APPLICATION NO	D.	FILING DATE	FIRST NAMED INVENTOR	ATTORNEY DOCKET NO.	CONFIRMATION NO.
10/762,463	·	01/23/2004	Yoshihiro Nakazawa	0505-1262P	5469
2292	7590	04/26/2005		EXAMINER	
		ART KOLASCH &	HURLEY, KEVIN		
PO BOX 747 FALLS CHURCH,VA 22040-0747				ART UNIT	PAPER NUMBER
		•		3611	
				DATE MAILED: 04/26/2005

EXAMINER'S AMENDMENT

Fig. 3

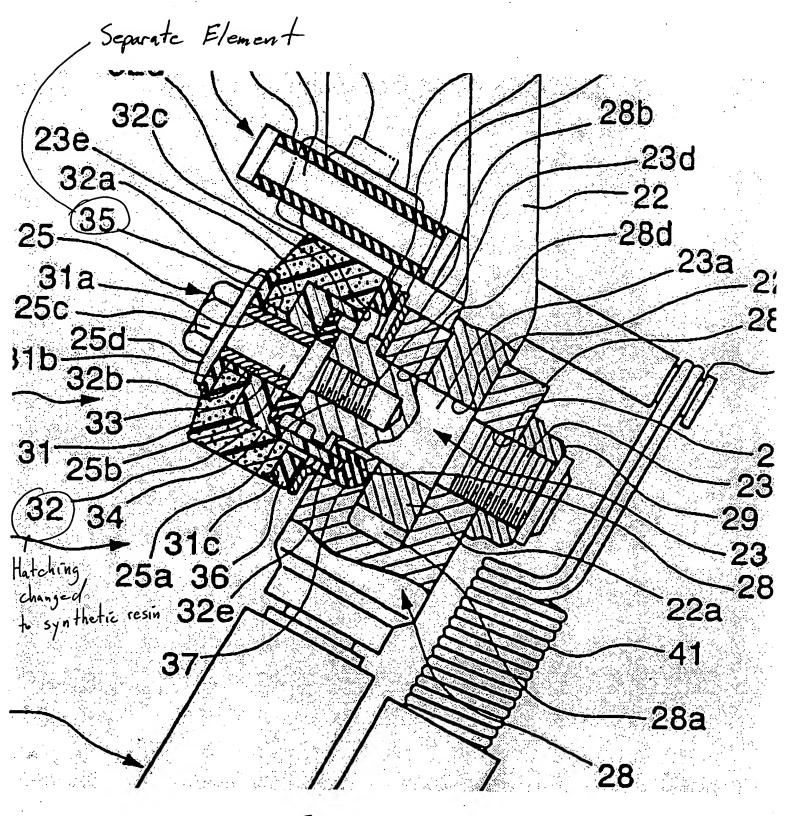
In Fig. 3, annular rubber sheet 35 has been shown as a separate element.

In Fig. 3, the hatching of inner rotor 32 has been corrected to synthetic resin.

An enlarged portion of Fig. 3 with the above changes made is attached.

In order to avoid abandonment of the application, applicant must make these above drawing changes.
